STAFF REPORT: 08/13/2025 REGULAR MEETING

APPLICATION NUMBER: HDC2025-00489

ADDRESS: 2733 SECOND AVENUE (AKA CASS PARK)

SCOPE: REHABILITATE PARK, REVISE INTERNAL PATH LAYOUT

Excerpt from page 22 of applicant's document.

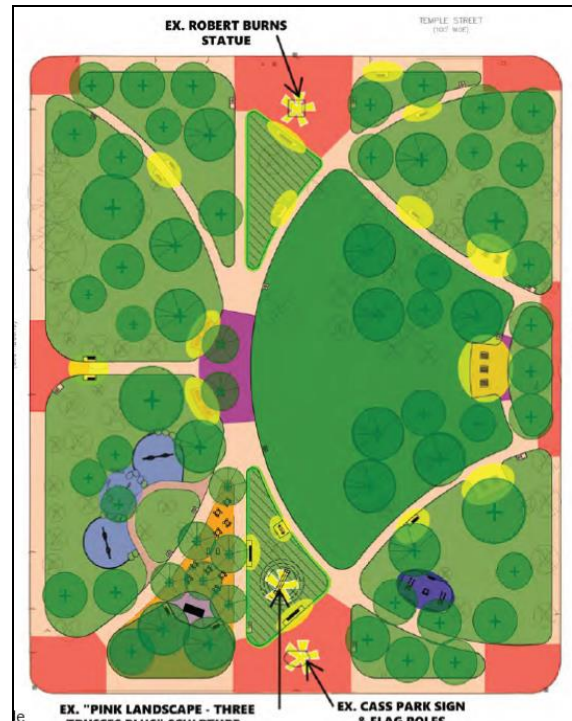
- Staff walked the perimeter path along the circumference of the park (south, west and north sides). The narrow path's placement within the tree canopy and surrounding landscape offered a quiet pastoral park experience, in contrast to the formal and monumental experience when walking on the wide paths toward the center of the park and outward to the entrances/exits.
- While not a historic feature, it is a very nice walking experience. It is not identified on the proposed site plan, so staff assumes it is to be removed as part of the proposed rehabilitation.

- Taking into account the district's Elements of Design and the park's level of integrity, it is staff's opinion that the proposed layout is not a compatible design as it will destroy the distinctive character-defining features of the park. The applicant referenced the Elements of Design in its presentation document and offered comments on how these elements were addressed in the proposed design. They are reprinted here, along with staff's reply.

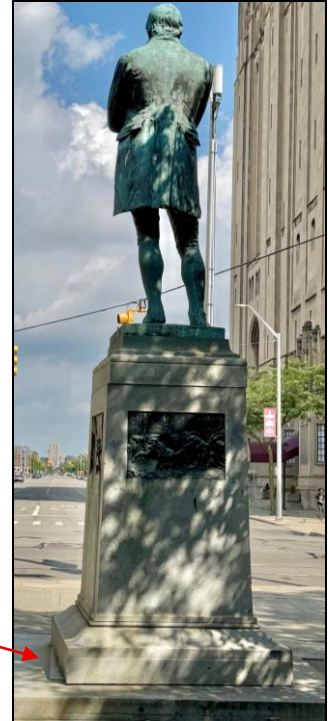
“The statue of Robert Burns sits on the northern edge of Cass Park, centered on its block face, and faces north along Second Avenue.”

The statue of Robert Burns remains in the same prominent location in the northern edge of the park, with minor repairs to the base.

Staff: Staff noticed the shift of the monument on its base and highlights this issue in the photos below. The base is inscribed and is one of many components that comprise the statue, which is distinctive character-defining feature of the park. A detailed, bulleted scope of work for the “minor repairs” must be submitted for staff review prior to work taking place.
